P98-102 4121 and 4127 14th Avenue - Parking lot for St. Paul's  
Missionary Baptist Church

- REQUEST:
- A. Categorical Exemption (Section 15303, 15305 and 15311);
  - B. **Special Permit** to allow an 84 space off-site parking lot for an existing church;
  - C. **Variance** to reduce the required 50% tree shading requirement to 25%;
  - D. **Variance** to waive the six foot high masonry wall that is required between the non-residential use and the adjacent residential uses; and,
  - E. **Lot Line Merger** to merge two parcels into one parcel on a .66 ± acre parcel in the Heavy Commercial (C-4) zone.

LOCATION: 4121 and 4127 14th Avenue  
APN:014-0272-035 and 036  
Council District 5

# OVERFLOW PARKING FOR ST. PAUL MISSIONARY BAPTIST CHURCH

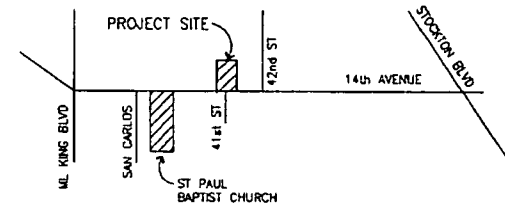
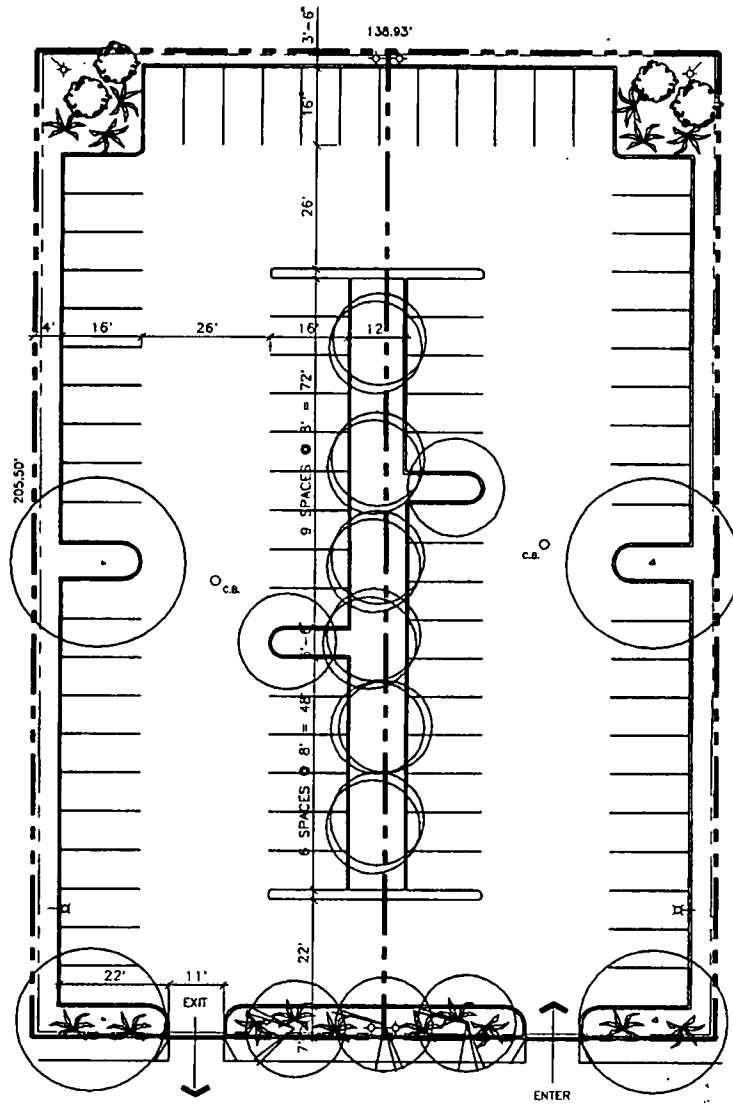
The site plan shows a rectangular shaped parking lot for 84 vehicles. The plan provides for 25% tree shading of the overall lot. A decorative wrought iron fence is proposed along the front of the property. The proposed decorative fence includes images of children at play. The applicant proposes a six foot high chain link fence between the parking lot and adjacent residences.

The Zoning Ordinance requires a six foot high masonry wall between residential and non-residential uses. The applicant states that the variance to waive that requirement is requested for two reasons: first, the masonry wall would be a target for graffiti; and, second, construction cost of \$500 per lineal foot of wall makes it prohibitive. Staff does not feel that there is sufficient hardship to support the requested waiver and recommends denying the variance to waive the required wall. The lot would then have a solid masonry wall on the east, west and north sides. The wrought iron fence would be placed along the street frontage (south side).

Staff recommends that the variance to reduce the tree shading requirement be denied. A denial of the request will require the applicant to provide landscaping to the 50% level required by the Zoning Ordinance. Staff supports maintaining the required tree shading due to its aesthetic value, and its value in reducing the amount of heat generated by the parking lot paving. Tree shading also reduces emissions by cooling fuel tanks. Conditions of approval are recommended to maintain landscaping in a way that it will not disturb security.

Staff recommends that the masonry wall be provided as required to help improve the aesthetics of the parking lot and to provide a buffer between adjacent residential properties.

8. Automatic sprinklers shall be provided for landscaped areas to the satisfaction of the Planning Division.
  9. A six foot high masonry wall is required along the east, west and north property lines around the parking lot. Materials for the wall should consist of split faced block or other units to enhance the appearance of the parking lot. Materials to be used shall be reviewed and approved by Planning staff prior to the issuance of the building permit.

TYP. GATE SECTION

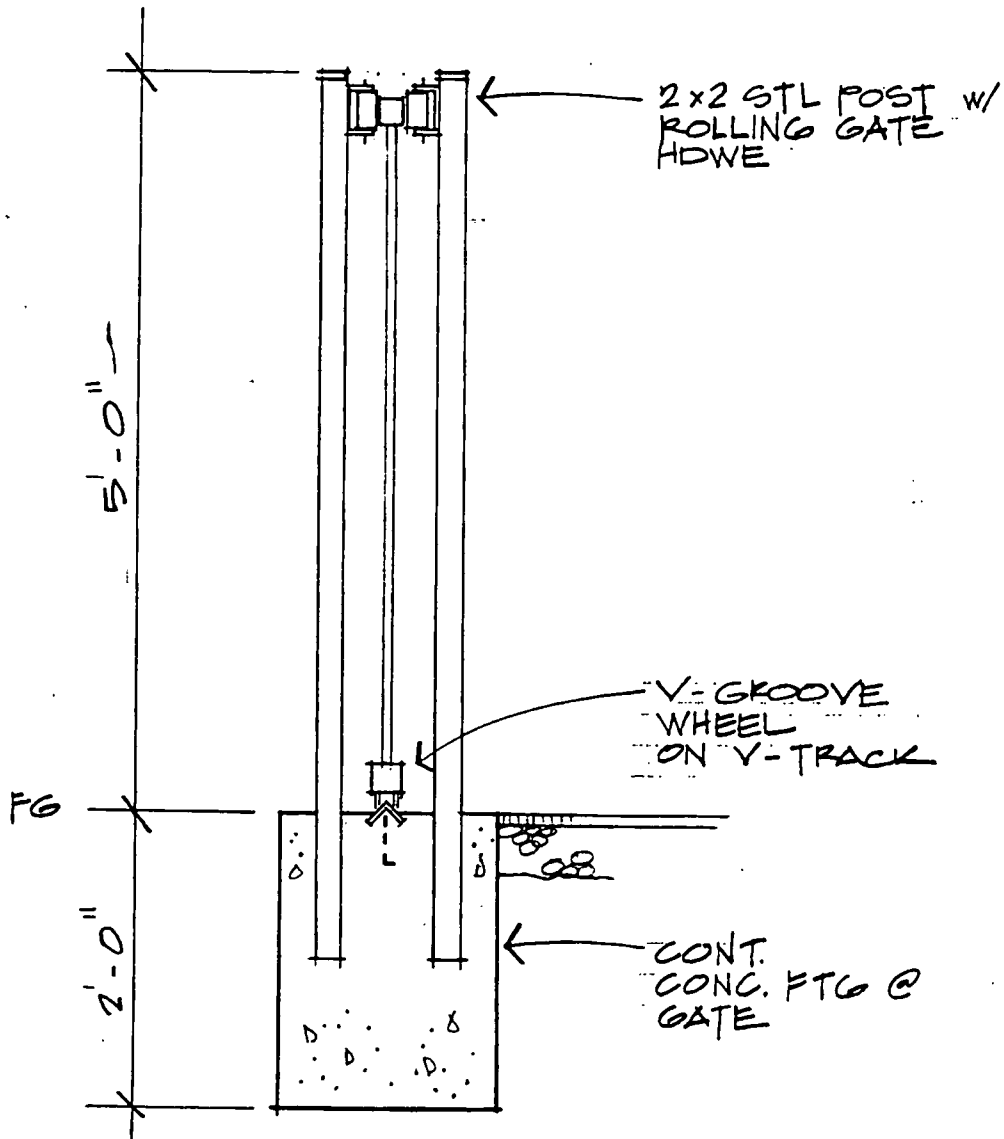
bumper stops will be in conformance with City Standards. The five foot high decorative wrought iron fence proposed along 14<sup>th</sup> Avenue is a desirable feature. The fence shall be installed along the north side of the planter (about four feet behind the side walk) so that the plants are on the street side of the fence. The plan has adequate room for landscaping. Staff recommends that the types of plant materials used should be reconsidered. Flowering shrubs are preferred. The gate(s) shall be reviewed and approved by the Fire Department, Planning Division, Transportation Division of Public Works and Building Division. Gates shall be opened prior to church services and other related activities. The gates shall be closed and secured upon conclusion of church activities in the evenings.

4. Gates shall be opened prior to church services and other related activities. The gates shall be closed and secured upon conclusion of church activities. The gated entry shall be reviewed and approved by the Fire Department, Planning Division, Transportation Division of Public Works and the Building Division prior to issuance of a building permit.
